CITY OF KIRKLAND

NE 85TH ST PED-BIKE CONNECTION
114TH AVE NE TO 6TH ST
JOB NO. 37-24-PW CIP No. STC1070000

ADDENDUM No. 3 TO THE PLANS, SPECIFICATIONS, PROPOSAL AND CONTRACT

Issued This Date: Friday, January 31, 2025
Bid Opening: **Unchanged – February 5, 2025**
Place of Opening: City Hall, Council Chambers

DWG. NO. RP1

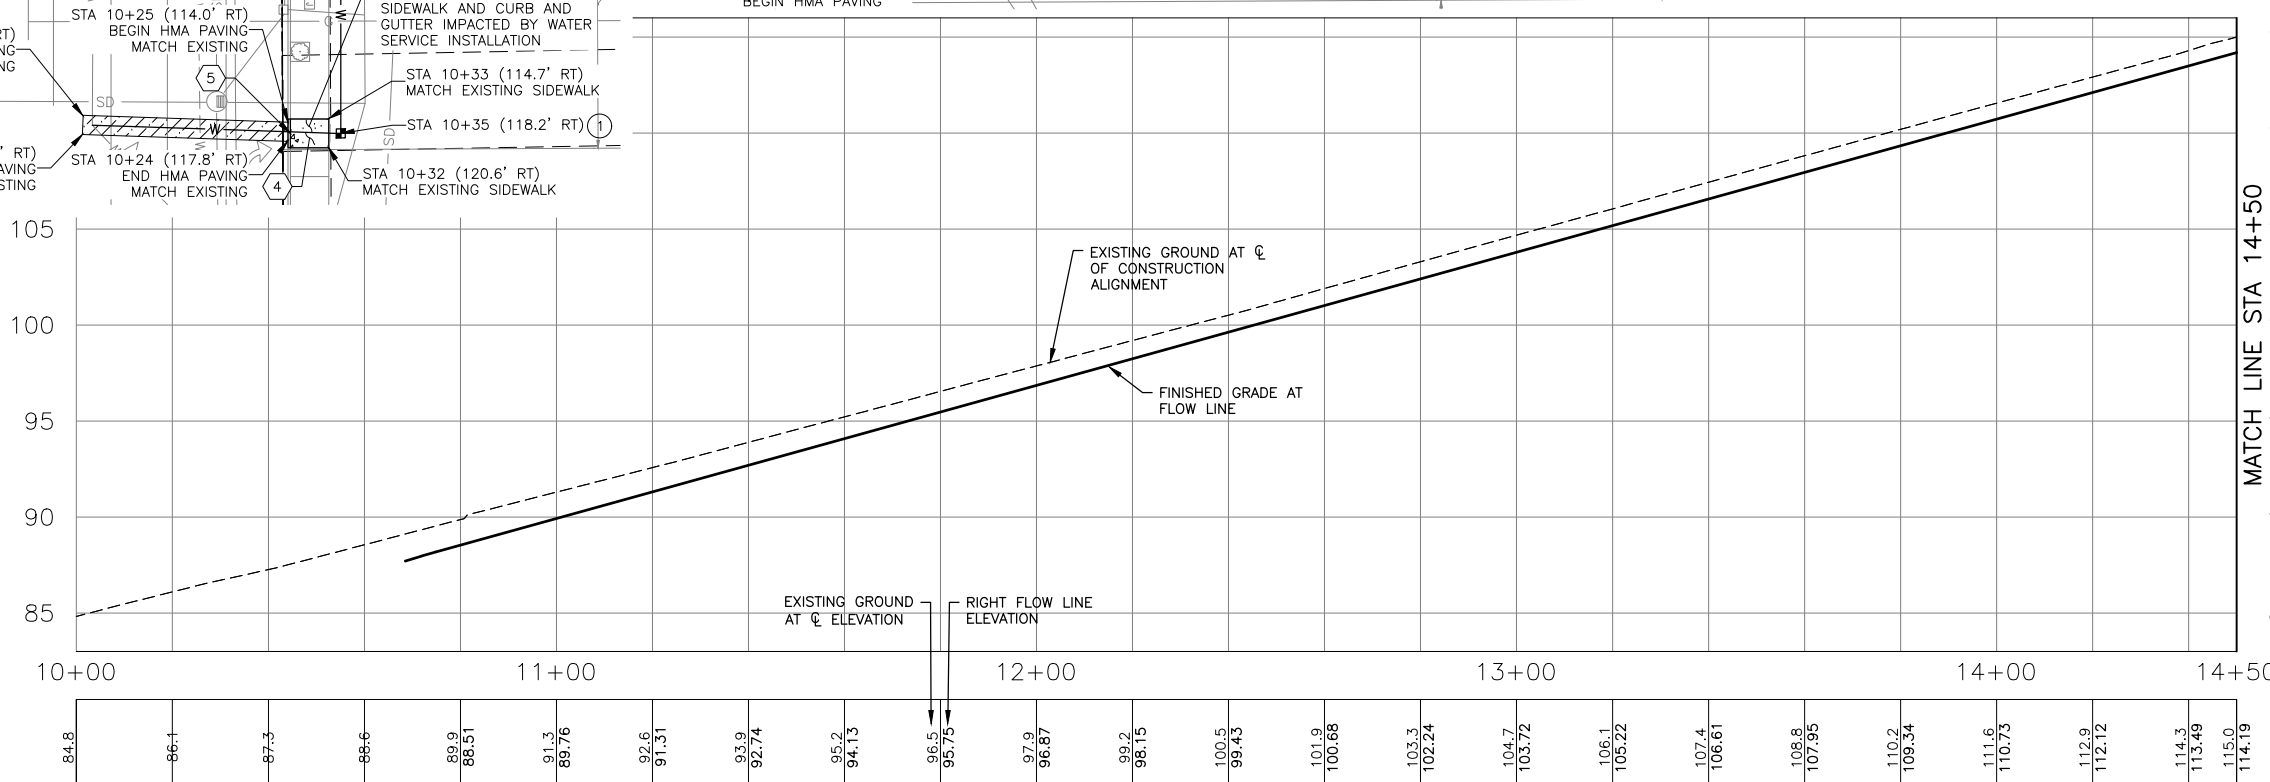
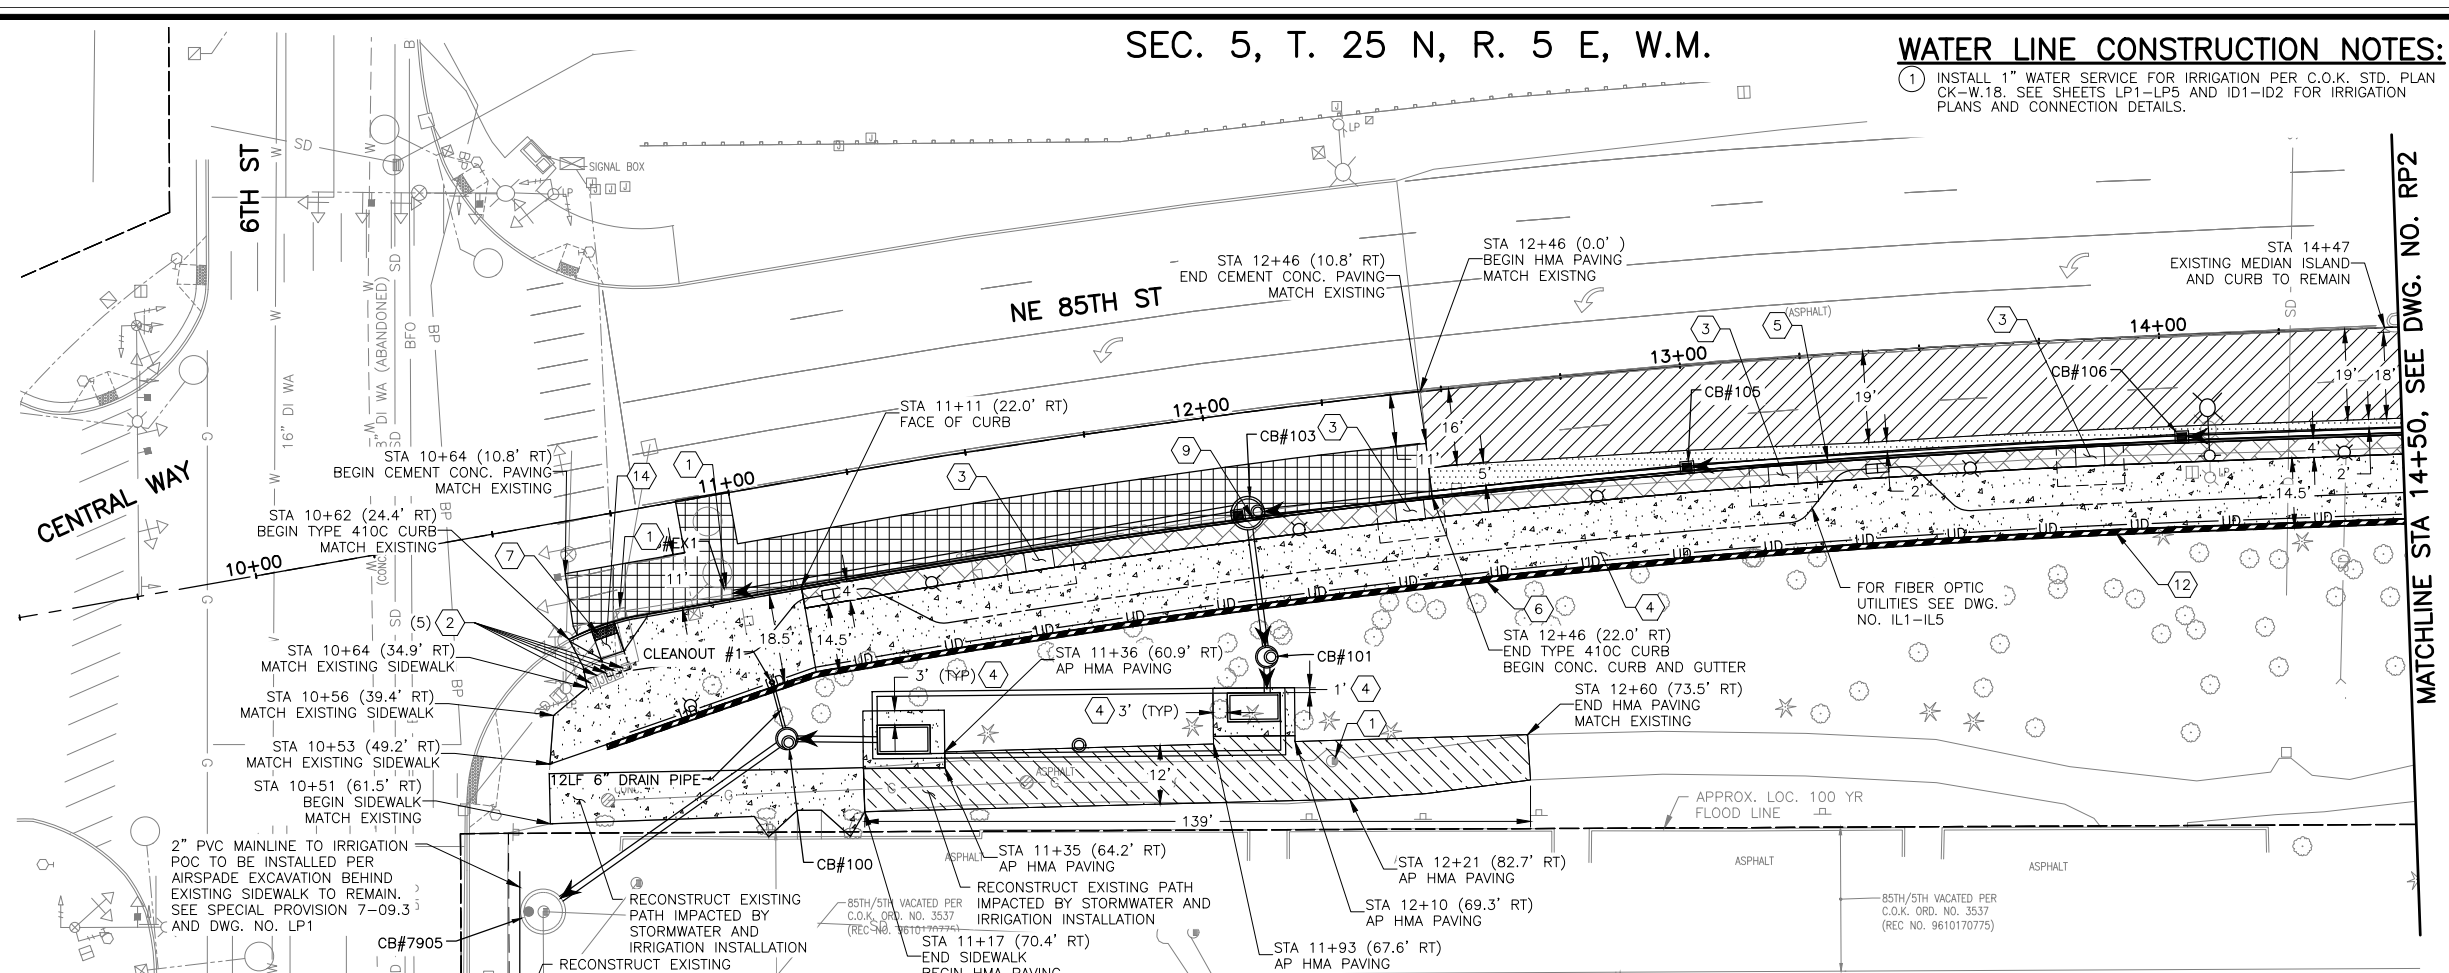
- I. Roadway plan and profiles call out 6" stamped concrete and details show 4" stamped concrete. Please let us know which is the intention.
 - a. The roadway plan legend should be revised to 4" to match the details on RD3.

FILE	ENGR.	REVIEW	SCALE	DATE
RP1	##	##	AS SHOWN	JANUARY 2025
Δ	STAMPED CONC. DEPTH UPDATE	VWW	VWW	1/31/2025
NO.	REVISION	BY	REVIEW	DATE

DWG. NO. RP2

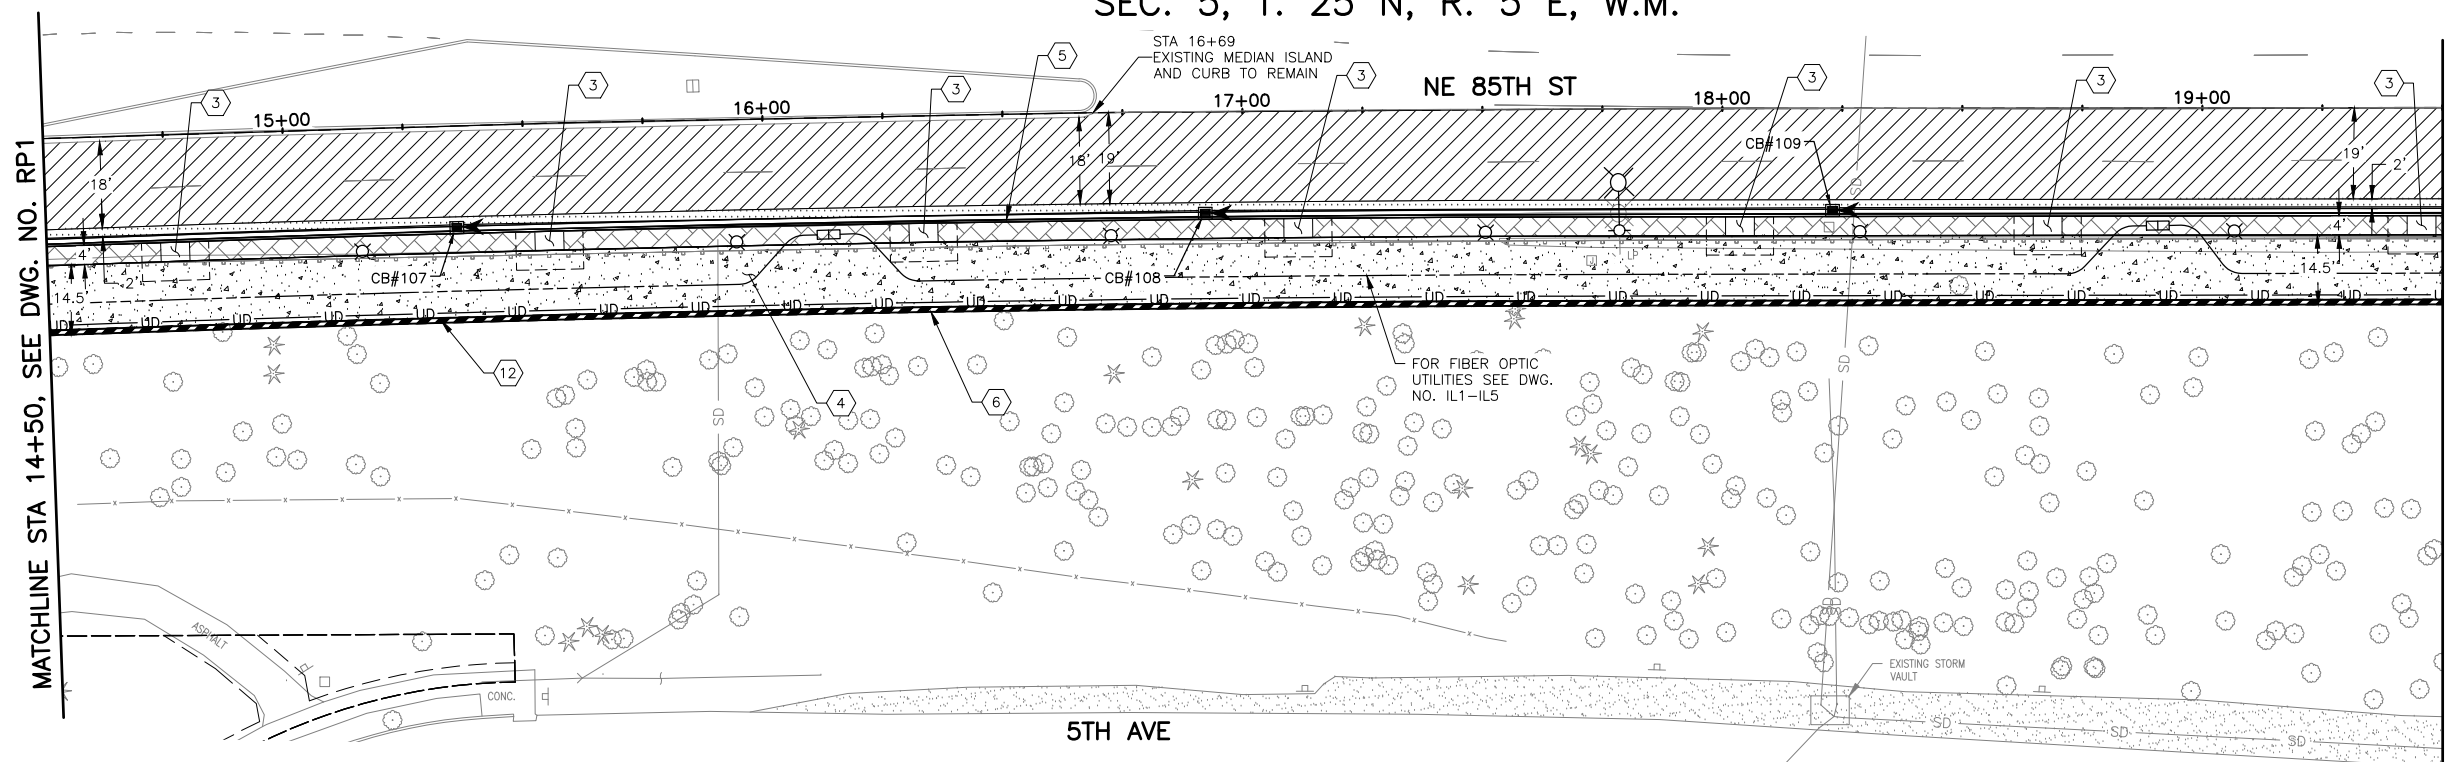
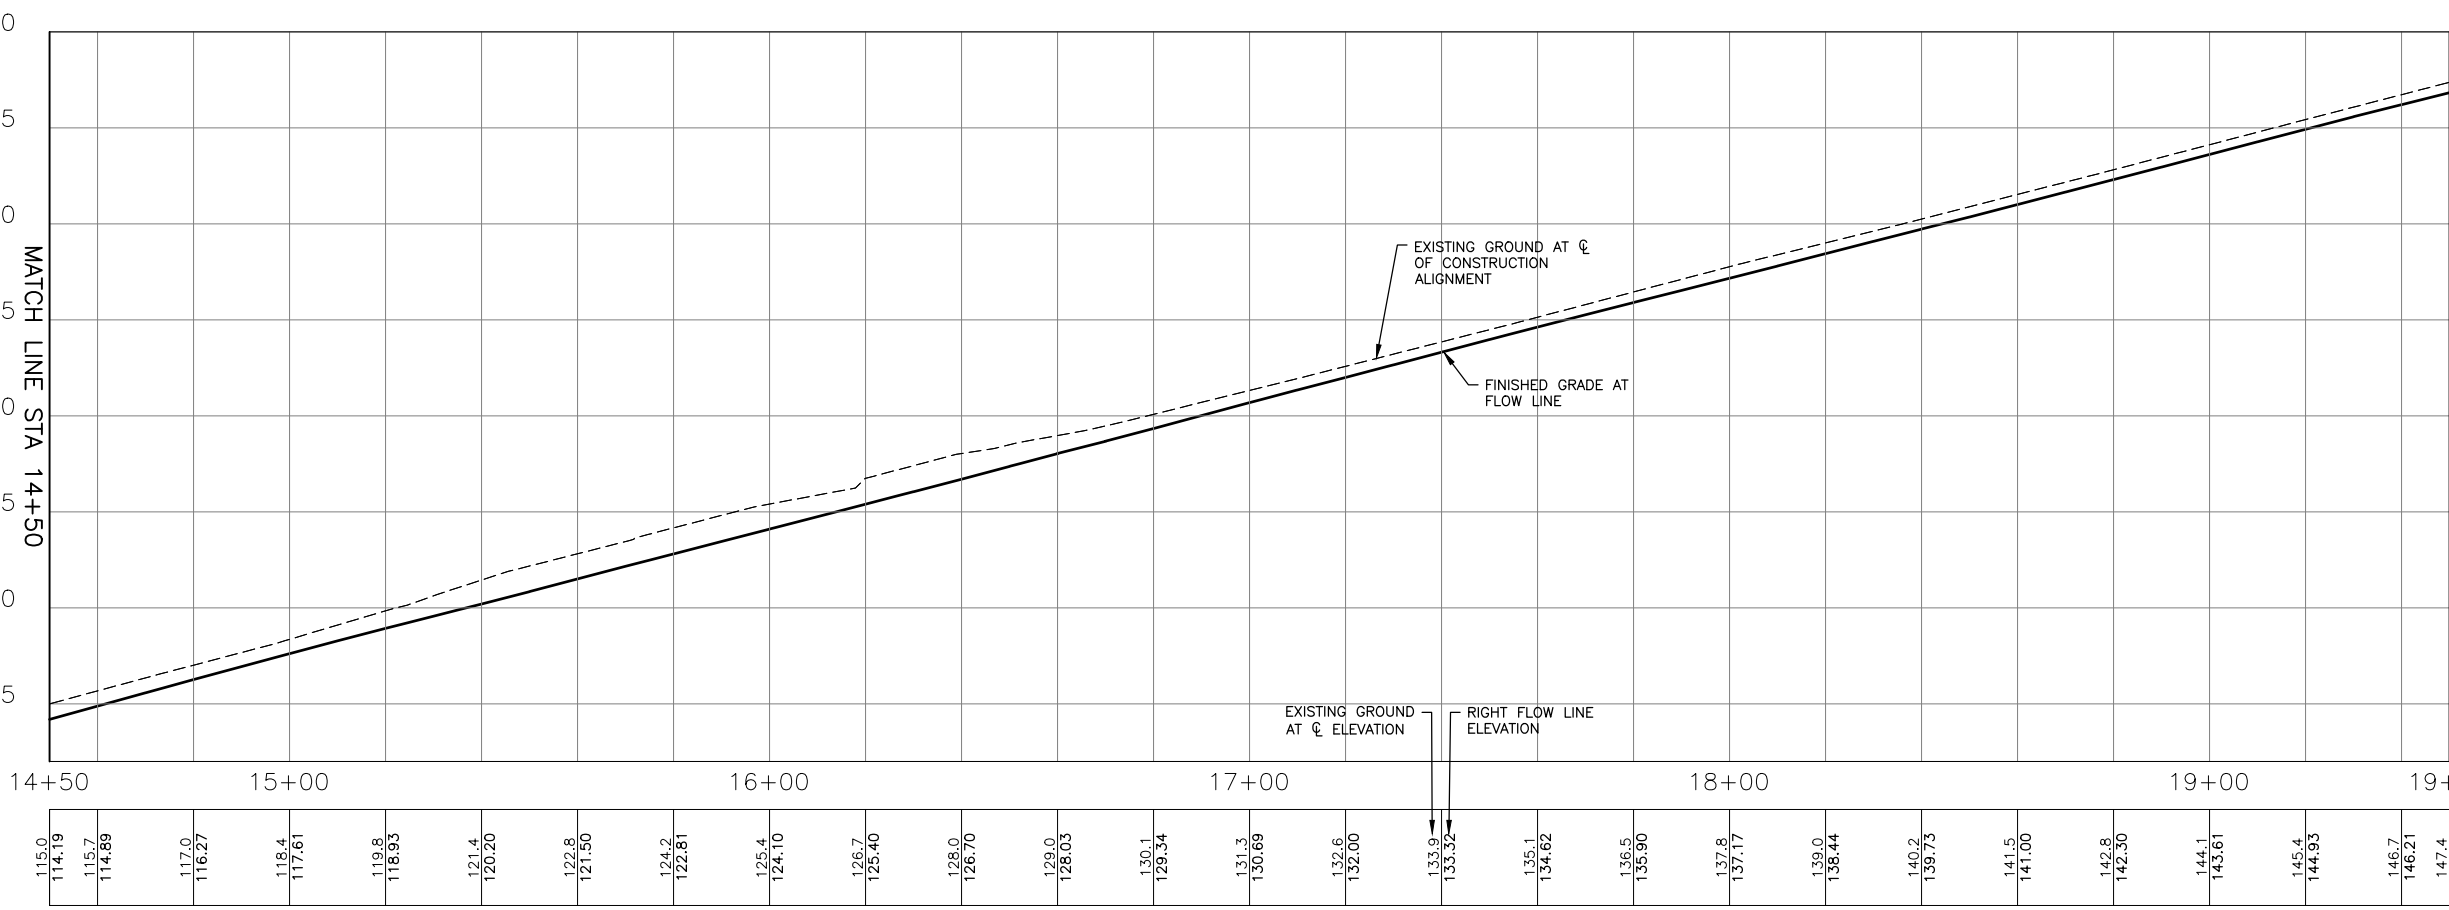
FILE	ENGR.	REVIEW	SCALE	DATE
RP2	##	##	AS SHOWN	JANUARY 2025
Δ	STAMPED CONC. DEPTH UPDATE	VWW	VWW	1/31/2025
NO.	REVISION	BY	REVIEW	DATE
